JORDAN VALLEY WATER TREATMENT PLANT
FILTER AND CHEMICAL FEED UPGRADES

JVWCD PROJECT #4289

ADDENDUM NO. 2
TO THE
CONTRACT DOCUMENTS

APRIL 2025

- GENERAL NOTES:**
- PROVIDE MINIMUM INTERIOR DIMENSIONS AS SHOWN IN THE ELECTRICAL HANDHOLE AND MANHOLE SCHEDULE.
 - BOND ALL METALLIC ITEMS INSIDE HANDHOLE TO GROUND ROD USING #4 AWG BARE COPPER CABLE.
 - SEE DRAWINGS FOR ORIENTATION, NUMBER, AND SIZE OF DUCT BANKS AT EACH HANDHOLE.

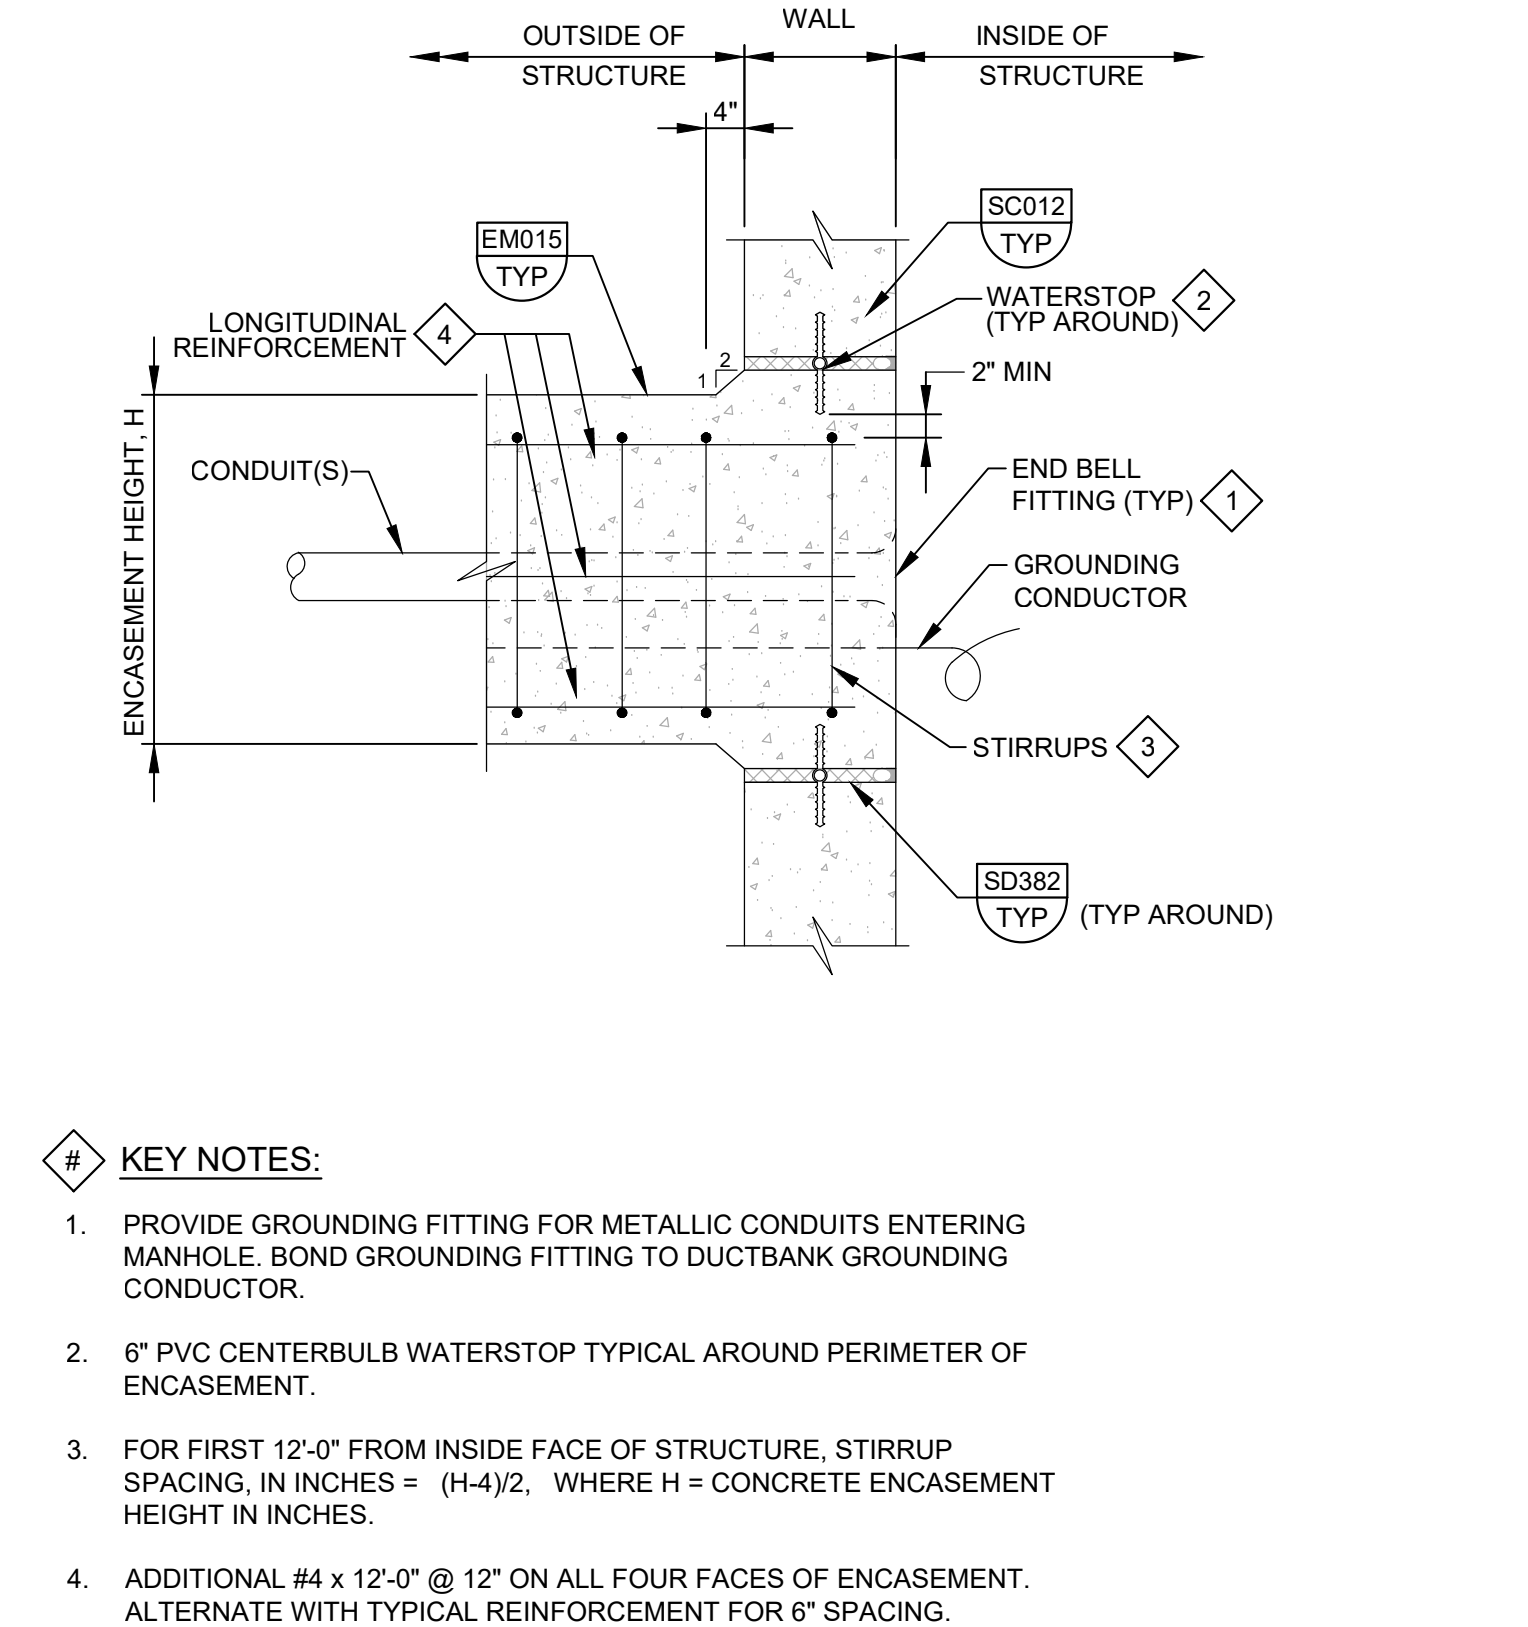
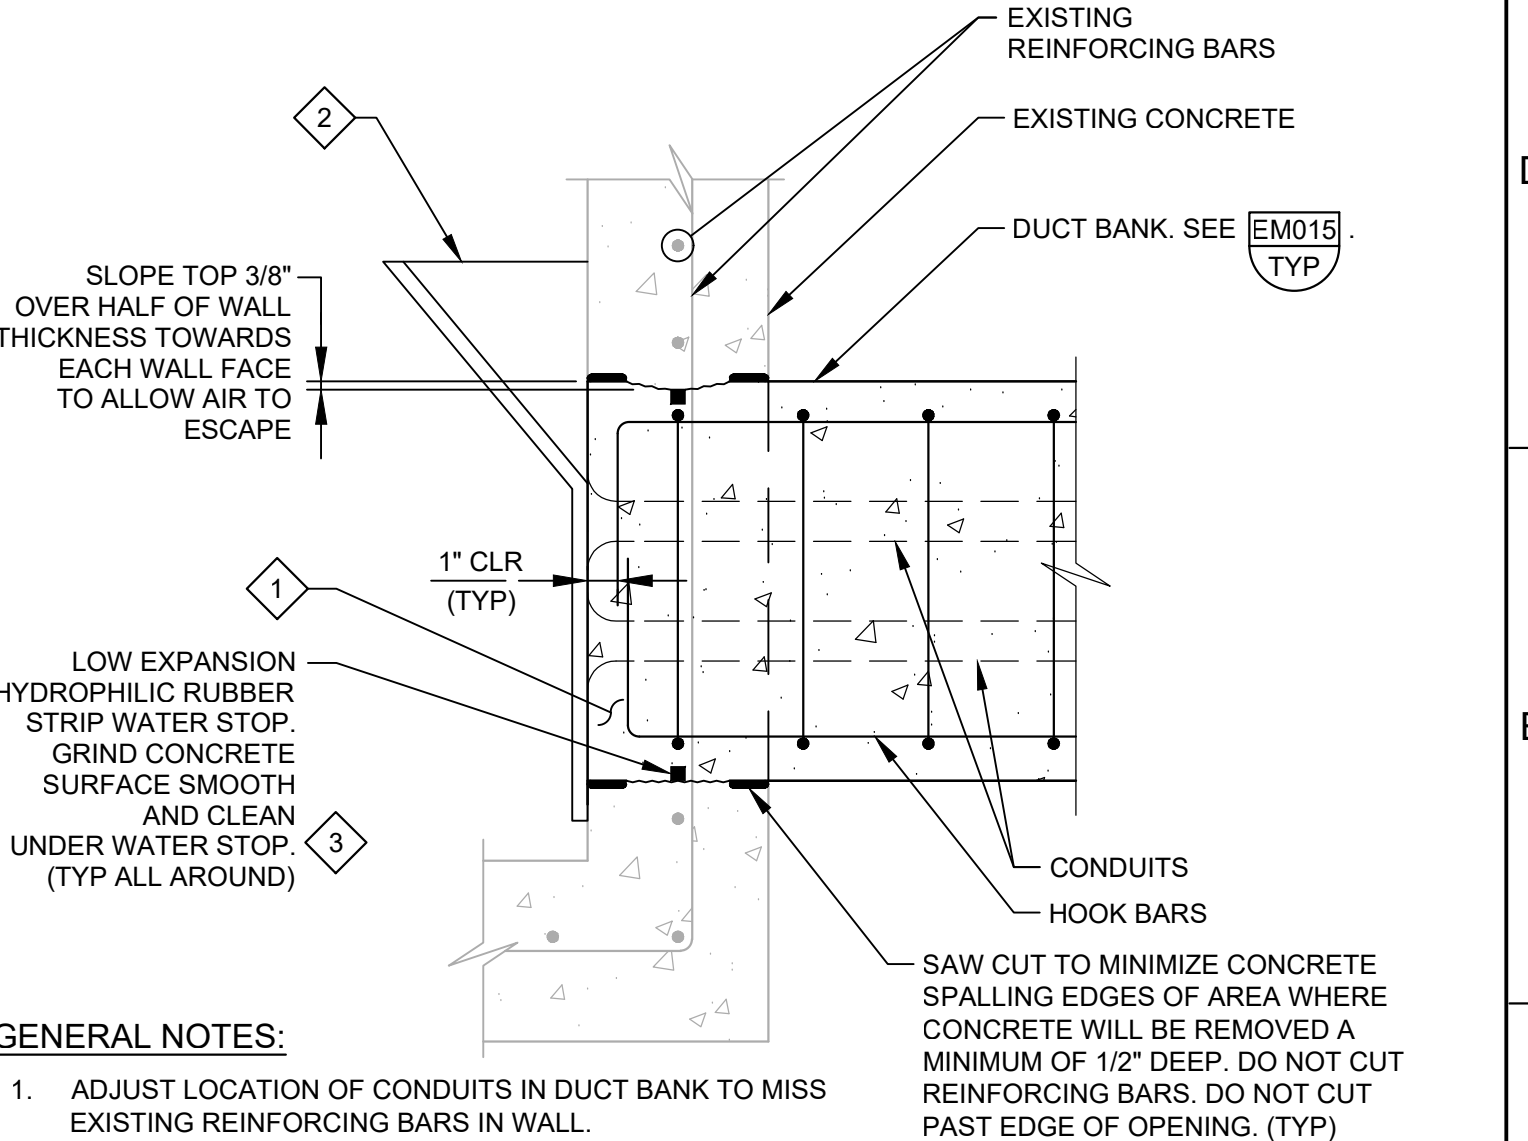
EM015 PEA GRAVEL EMBEDDED DUCT BANK
TYP
01/23/25

EM021 DUCT BANK CROSSING UNDER FOOTER
TYP
01/23/25

EM052 ELECTRICAL HANDHOLE: PRECAST POLYMER CONCRETE
TYP
01/23/25

EM071 ENCASED CONDUITS AT MANHOLES OR STRUCTURES - WITH WATERSTOP
TYP
01/23/25

EM072 DUCT BANK CONNECTION TO EXISTING HANDHOLE, PULL BOX, OR WALL
TYP
01/23/25

JORDAN VALLEY WATER TREATMENT PLANT
FILTER AND CHEMICAL FEED UPGRADES
ELECTRICAL
ENLARGED SITE PLAN 1

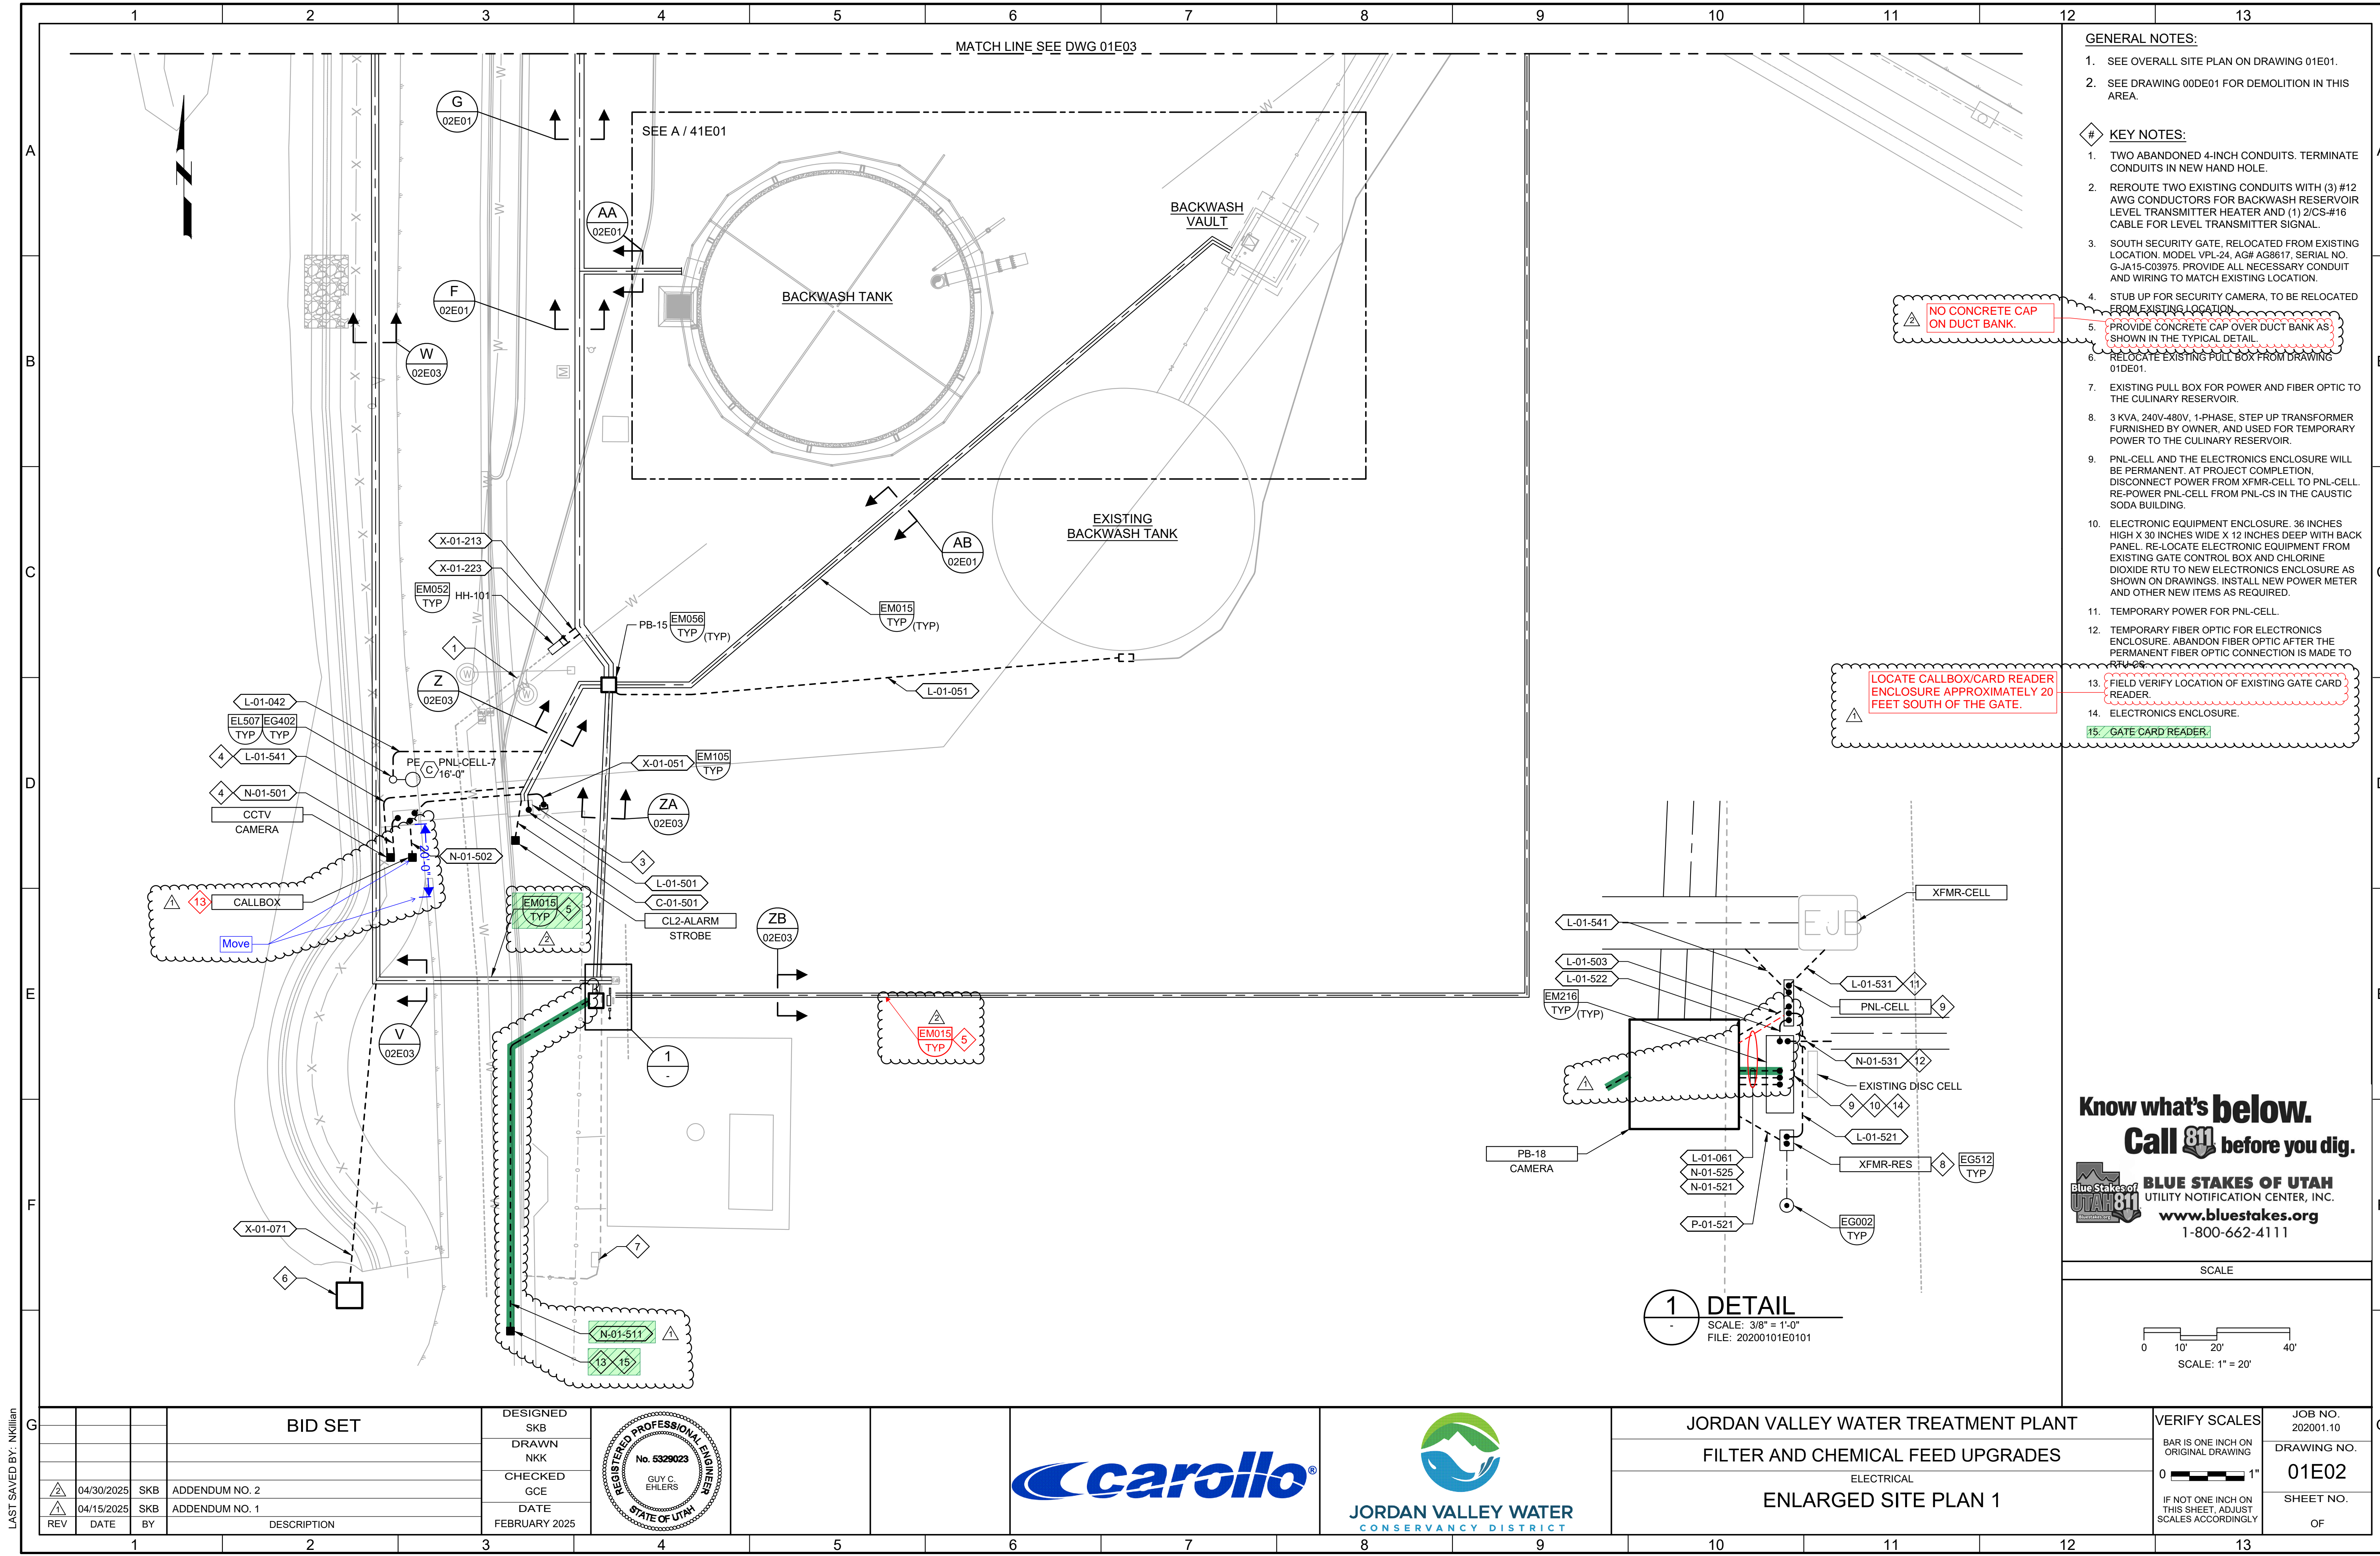
- SEE OVERALL SITE PLAN ON DRAWING 01E01.
 - SEE DRAWING 00DE01 FOR DEMOLITION IN THIS AREA.
- # KEY NOTES:
- TWO ABANDONED 4-INCH CONDUITS. TERMINATE CONDUITS IN NEW HAND HOLE.

- REROUTE TWO EXISTING CONDUITS WITH (3) #12 AWG CONDUCTORS FOR BACKWASH RESERVOIR LEVEL TRANSMITTER HEATER AND (1) 2/CS-#16 CABLE FOR LEVEL TRANSMITTER SIGNAL.

- SOUTH SECURITY GATE, RELOCATED FROM EXISTING LOCATION. MODEL VPL-24, AG# AG8617, SERIAL NO. G-JA15-C03975. PROVIDE ALL NECESSARY CONDUIT AND WIRING TO MATCH EXISTING LOCATION.

- STUB UP FOR SECURITY CAMERA, TO BE RELOCATED FROM EXISTING LOCATION.
 - PROVIDE CONCRETE CAP OVER DUCT BANK AS SHOWN IN THE TYPICAL DETAIL.
 - RELOCATE EXISTING PULL BOX FROM DRAWING 01DE01.

- EXISTING PULL BOX FOR POWER AND FIBER OPTIC TO THE CULINARY RESERVOIR.
 - 3 KVA, 240V-480V, 1-PHASE, STEP UP TRANSFORMER FURNISHED BY OWNER, AND USED FOR TEMPORARY POWER TO THE CULINARY RESERVOIR.

- PNL-CELL AND THE ELECTRONICS ENCLOSURE WILL BE PERMANENT. AT PROJECT COMPLETION, DISCONNECT POWER FROM XFMR-CELL TO PNL-CELL. RE-POWER PNL-CELL FROM PNL-CS IN THE CAUSTIC SODA BUILDING.

- ELECTRONIC EQUIPMENT ENCLOSURE. 36 INCHES HIGH X 30 INCHES WIDE X 12 INCHES DEEP WITH BACK PANEL. RE-LOCATE ELECTRONIC EQUIPMENT FROM EXISTING GATE CONTROL BOX AND CHLORINE DIOXIDE RTU TO NEW ELECTRONICS ENCLOSURE AS SHOWN ON DRAWINGS. INSTALL NEW POWER METER AND OTHER NEW ITEMS AS REQUIRED.

- TEMPORARY POWER FOR PNL-CELL.
 - TEMPORARY FIBER OPTIC FOR ELECTRONICS ENCLOSURE. ABANDON FIBER OPTIC AFTER THE PERMANENT FIBER OPTIC CONNECTION IS MADE TO THE GATE.

- FIELD VERIFY LOCATION OF EXISTING GATE CARD READER.
 - ELECTRONICS ENCLOSURE.
 - GATE CARD READER.
